SUSITNA HYDROELECTRIC PROJECT

**ACRES INTERNAL REVIEW BOARD
MEETING # 4**

**REPORT
SEPTEMBER 8, 1981**

MINUTES OF MEETING
held at the offices of
Acres Consulting Services,
Niagara Falls, Canada on
September 8, 1981

DEVIL CANYON LAYOUT STUDIES (R. Ibbotson)

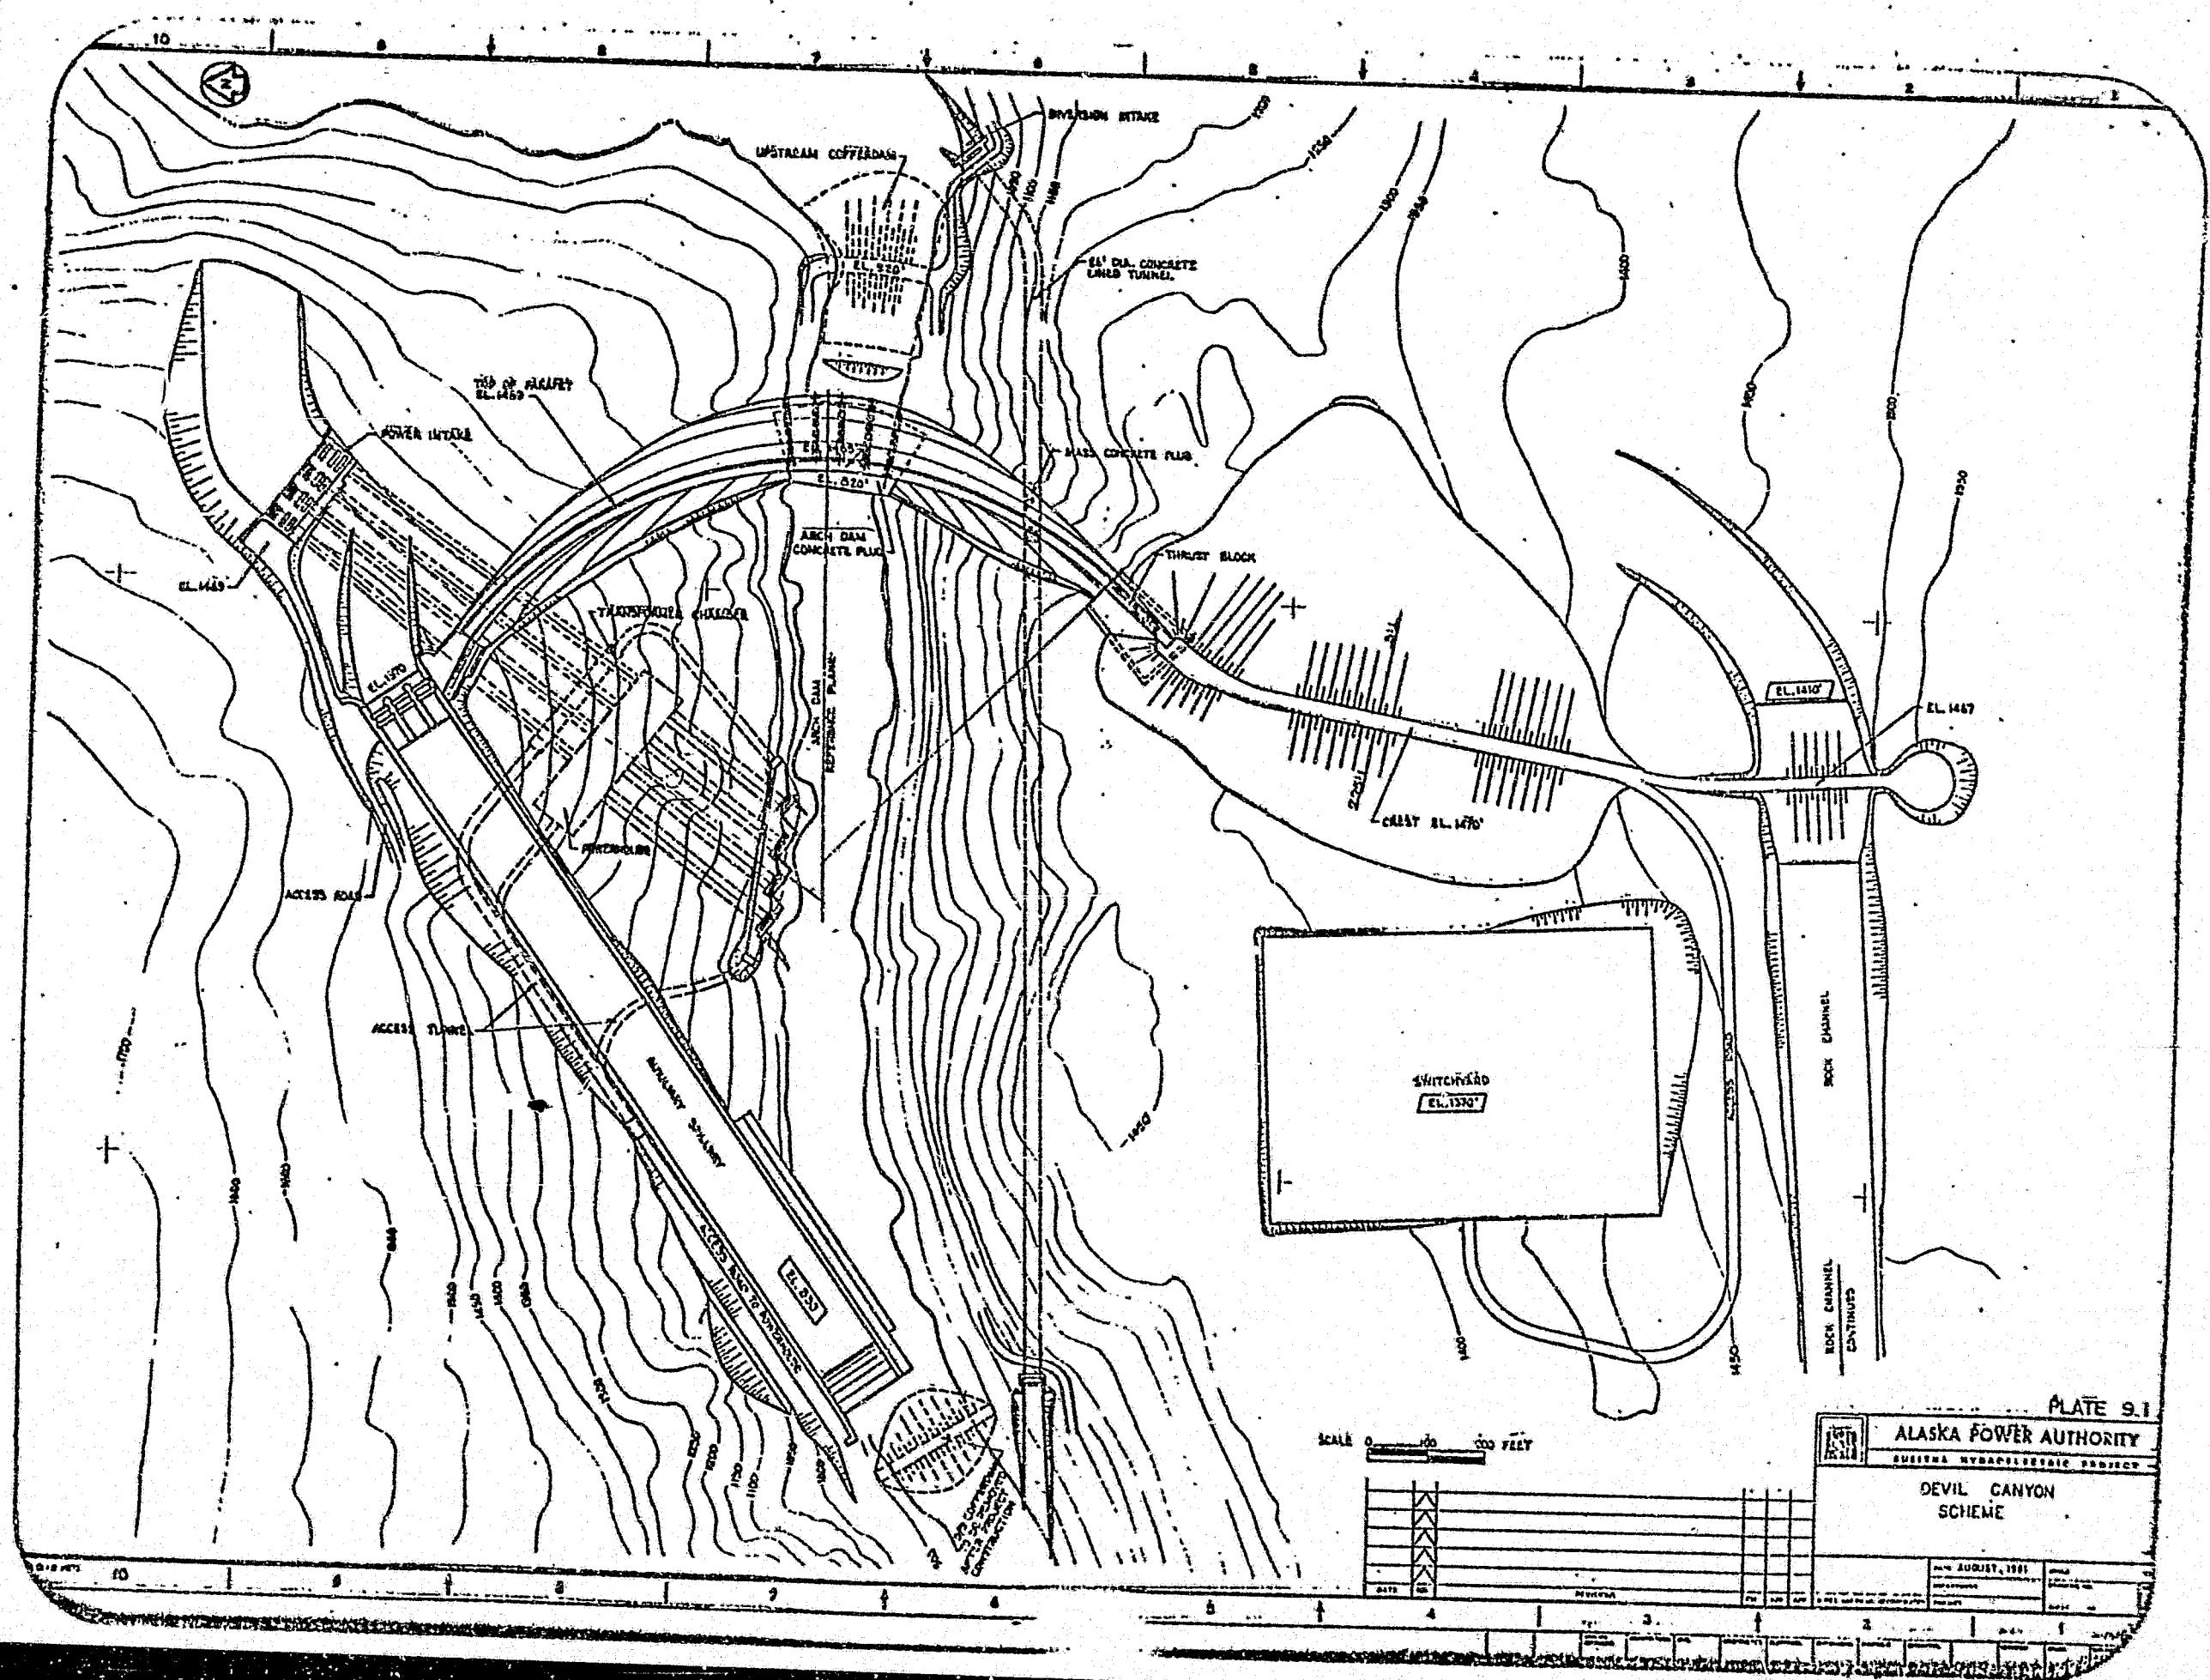
- Stilling basin walls are too thin if unsupported by rock.

- Need for precedent/experience report on HB valves particularly with regard to vibration and winter operation. Model studies will be required in design stage.
- Recommended at least 10D straight section before the valve to establish linear flow pattern, (particularly at Watana).
- To avoid supercooling the trashracks on the intake should not be exposed above W.L.
- Switchyard position is on opposite bank to powerhouse.
- Tailrace shown is freeflow; one extra set of gates?

The structural adequacy of the stilling basin at Devil Canyon was questioned. The fuse plug in the emergency spillway should, if possible, be replaced by a positive control.

Figure 8.1

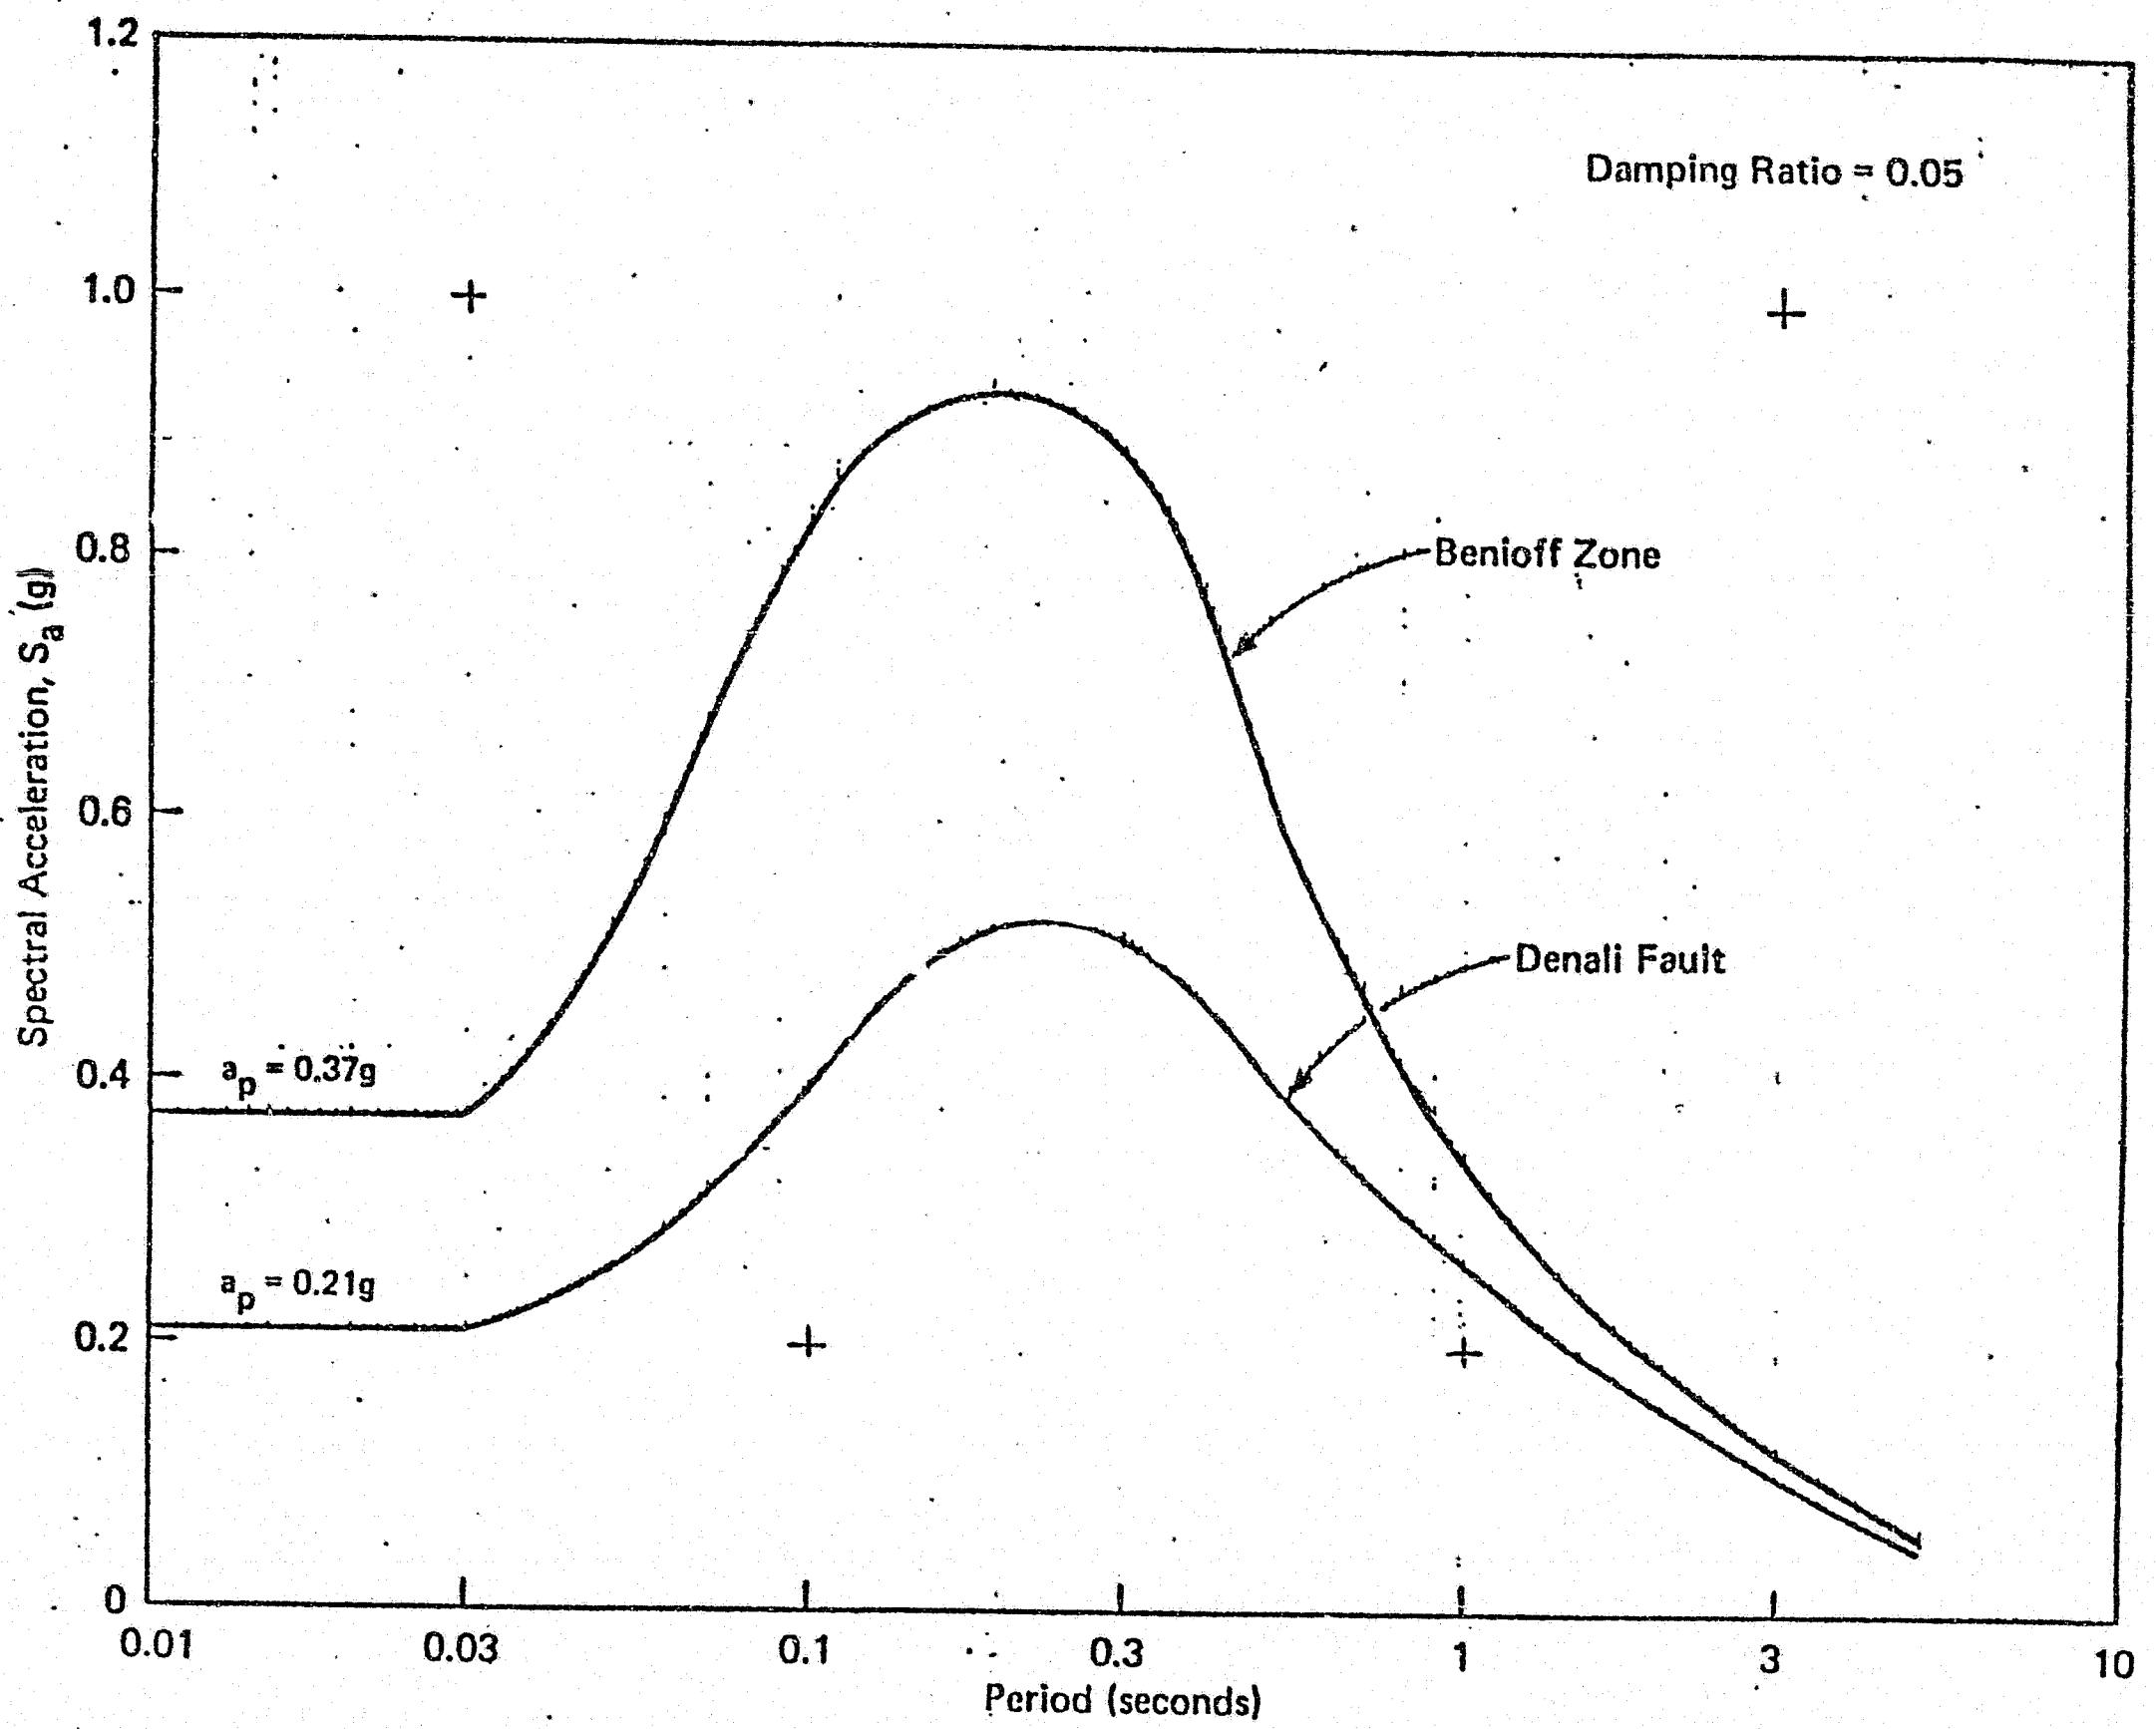
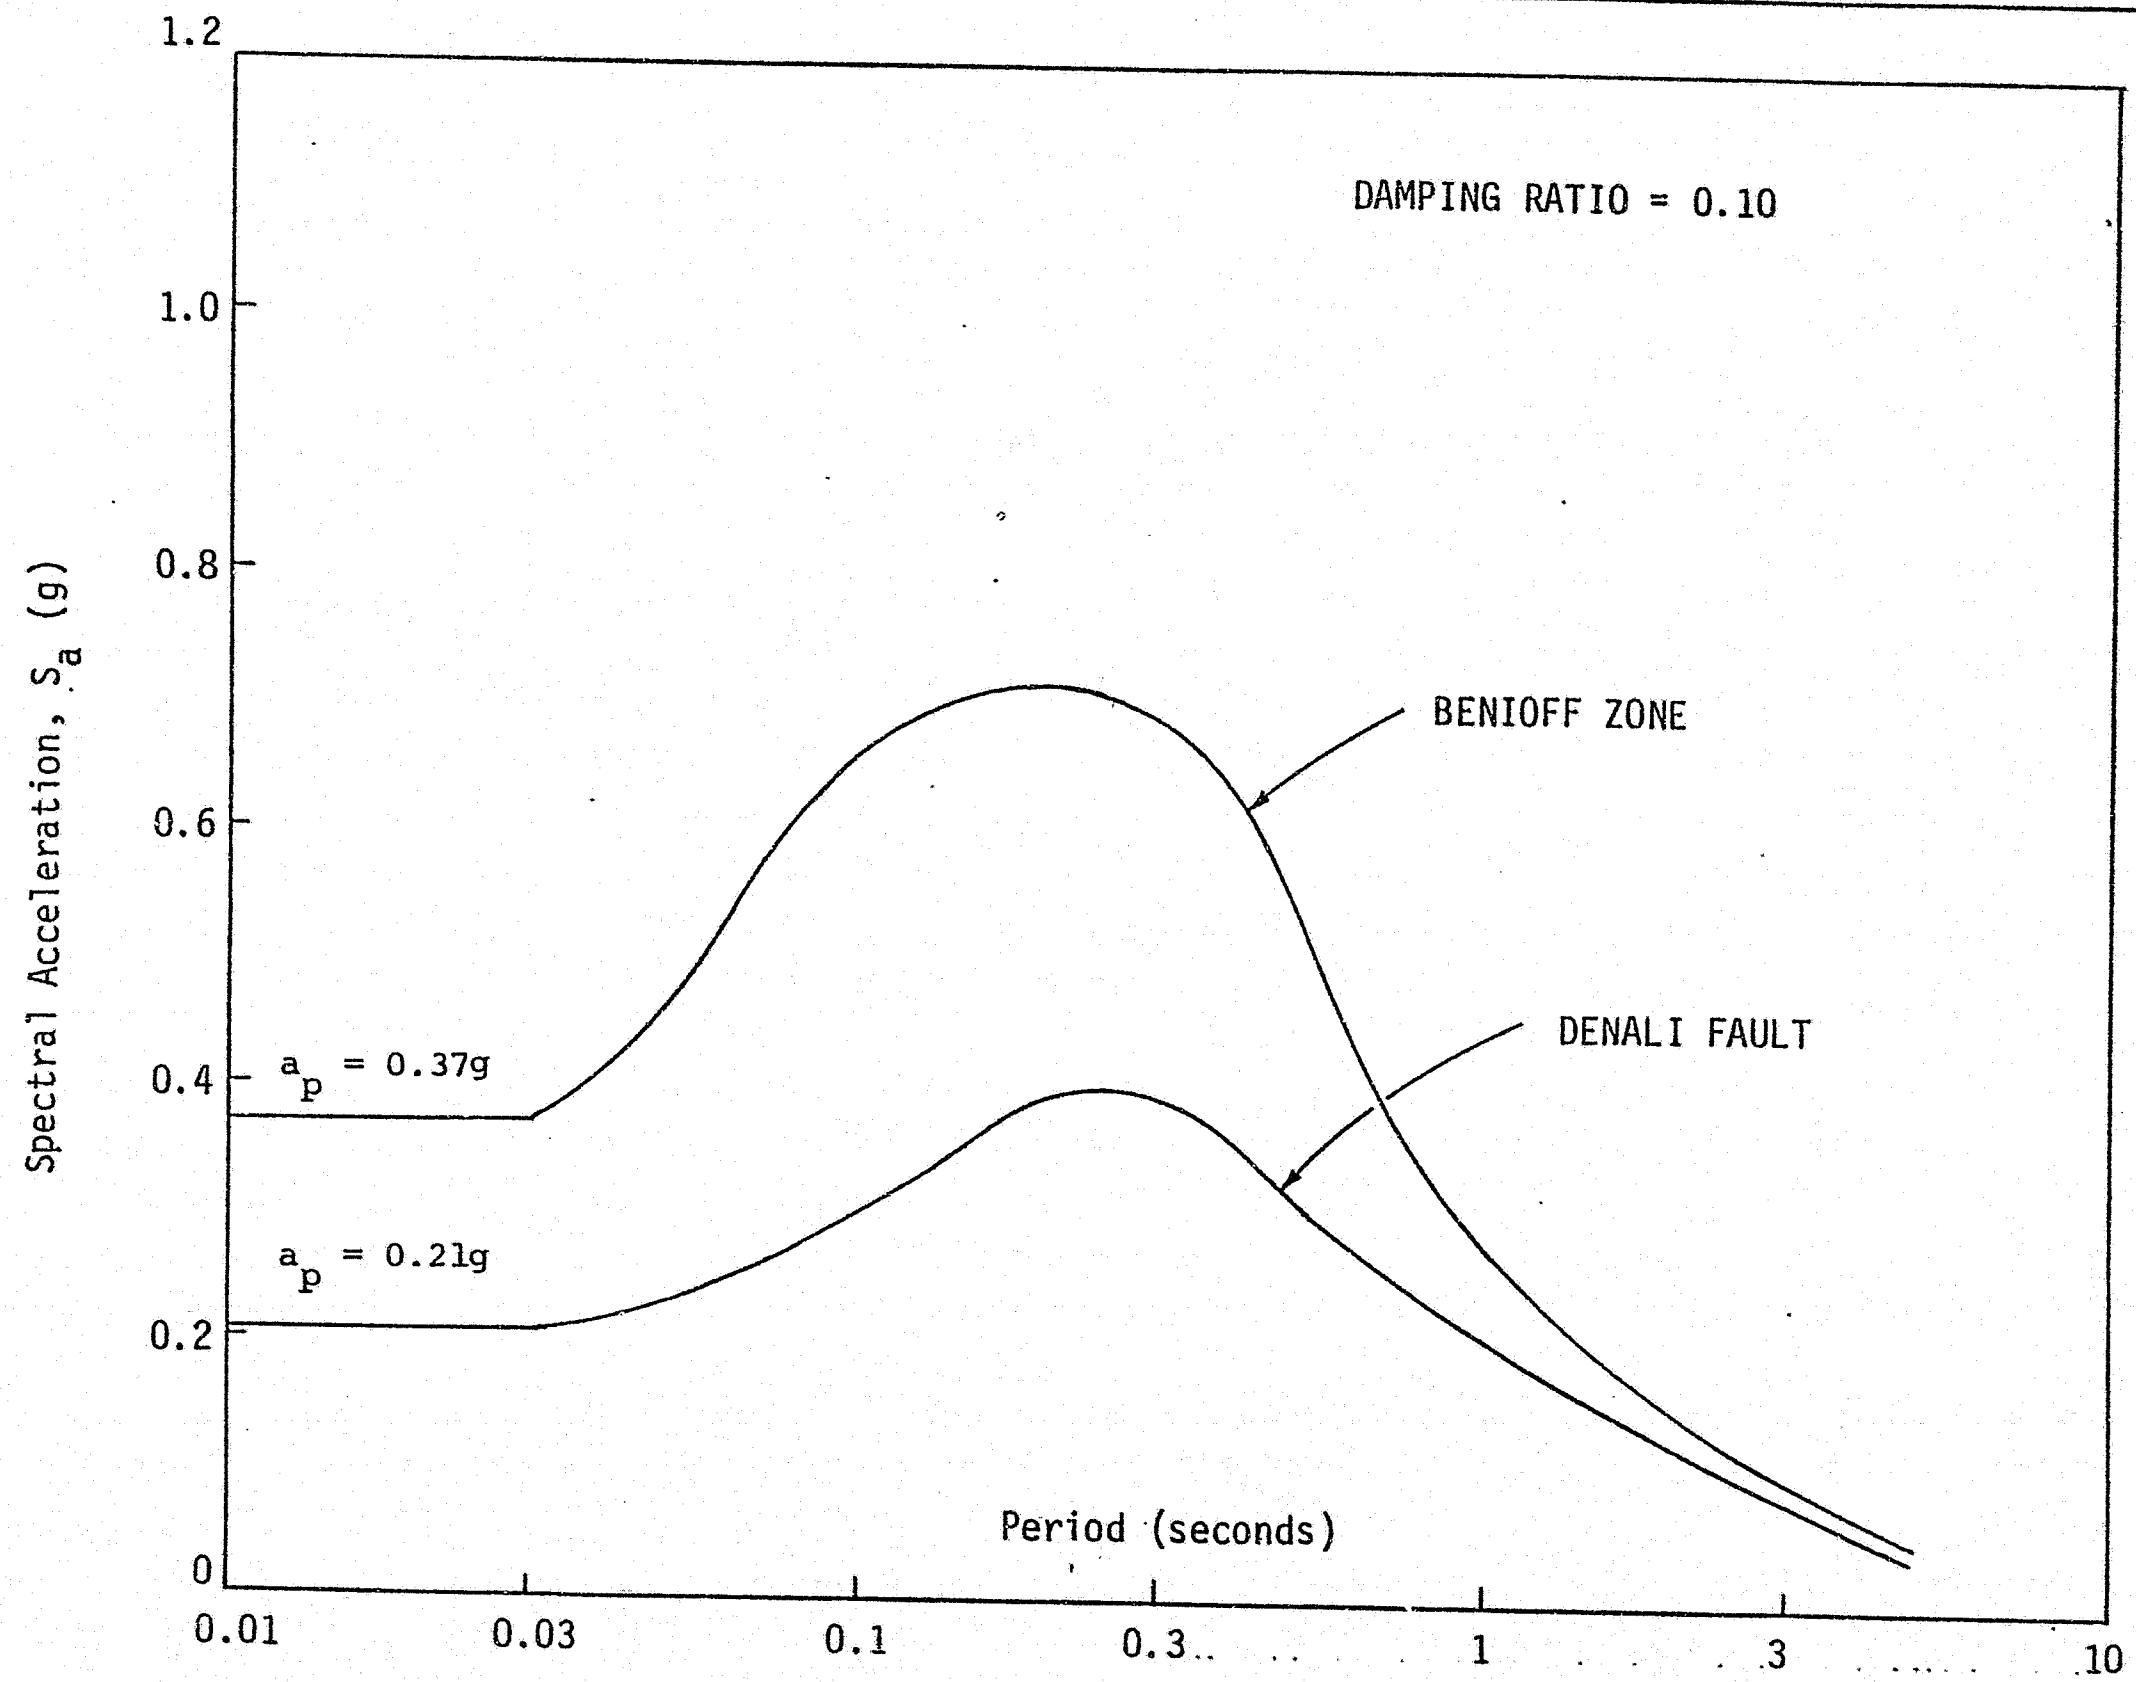
- Consider possible finite element analysis check on design by ISMES (Italy) D. Shandalov stated F.E. analysis does not allow for stress relief by cracking.
- Plastic non-recoverable deformation of abutments. This may be offset by grouting, which would tend to strengthen rock and give a more elastic response under load.
